Access Compliance Report

Public Rights-of-Way

(Curb Ramps)

Intersection ID: 21296	Main Street: E_ARROWOOD_RD	Cross Street: OLD_PINEVILLE_RD	Location: NE
ADA ID: 8D8A56AAC9B3	Ramp Type: Directional1	Initial Pass/Fail: Fail	Overall Compliance: No
Severity Score: 12.5			
Codes/Mitigation Info/Possible Solution		Field Measurements/Component Compliance

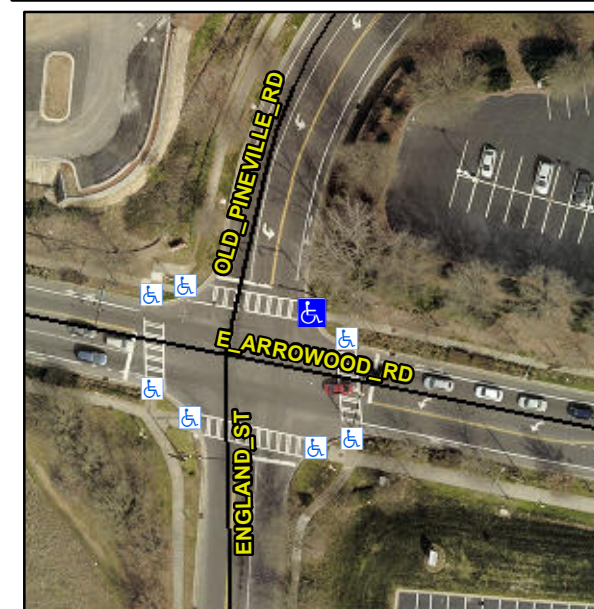
R304.5.3

Compliance	Description	Data	Compliance	Description	Data
N/A	Ramp Length (in)	77.0	N/A	Grade Break?	N/A
Yes	Ramp Width (in)	54.0	N/A	Grade Break Slope (%)	0.0
Yes	Ramp Slope (%)	3.6	N/A	Grade Break XSlope (%)	0.0
No	Ramp XSlope (%)	6.4			
N/A	Flare Type LT	N/A	N/A	Flare Type RT	N/A
N/A	Flare Slope LT (%)	N/A	N/A	Flare Slope RT (%)	0.0
N/A	Flare Traversable LT?	N/A	N/A	Flare Traversable RT?	N/A
N/A	Landing Length (in)	0.0	N/A	DWS Provided?	N/A
N/A	Landing Width (in)	0.0	N/A	DWS Contrast?	N/A
N/A	Landing Slope (%)	0.0	N/A	DWS Length (in)	N/A
N/A	Landing X Slope (%)	0.0	N/A	DWS Full Width?	N/A
N/A	Landing Curb? (Y/N)	N/A	N/A	DWS Offset LT (in)	N/A
N/A	Shared Landing?	N/A	N/A	DWS Offset RT (in)	N/A
N/A	Gutter Ponding?	0.0	N/A	Gutter Slope (%)	N/A
N/A	Gutter Lip Ht (in)	0.0	N/A	Gutter X Slope (%)	N/A
N/A	Painted X Walk1?	No		Road Slope (%)	1.3
	X Walk 1 Direction	To W		Road X Slope (%)	1.0
	X Walk 1 Width (in)	N/A		Clear Space?	N/A

Remove & Replace Entire Ramp.
